Release Note LS-300 VA1 v2.11.20.76

(This version is only compatible with the new HW version – VA1)

New Features and Modification of VA1

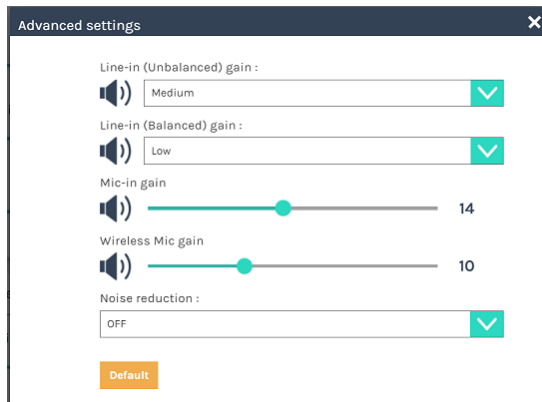
1. Differential audio input with phoenix type connector is “only” available on **LS-300**, **LS-400** and **KL-3T**.
2. Audio Noise Reduction (Line-in/Mic-in)
It can reduce the background noise that is present in recordings.
3. Audio Gain Control (Line-in/Mic-in)
Both balanced (Phoenix) and unbalanced (3.5mm) audio inputs have “Gain Control”.
 - Line-in (Unbalanced/Balanced): 3-step gain – Low, Medium, High
 - Mic-in/BT-Mic: 30-step gain

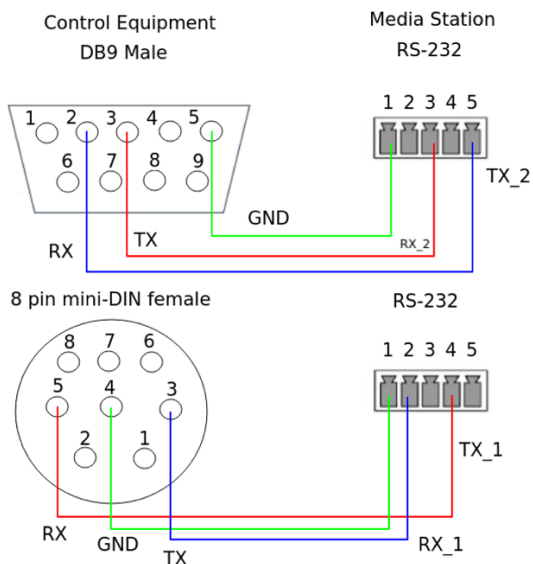
4. Equipped with one RE-232 camera control port
The same RS-232 port can now send commands for camera control while receiving commands from control systems.
* It can only control one camera, for additional cameras, USB-RS-232 cables will still be needed.
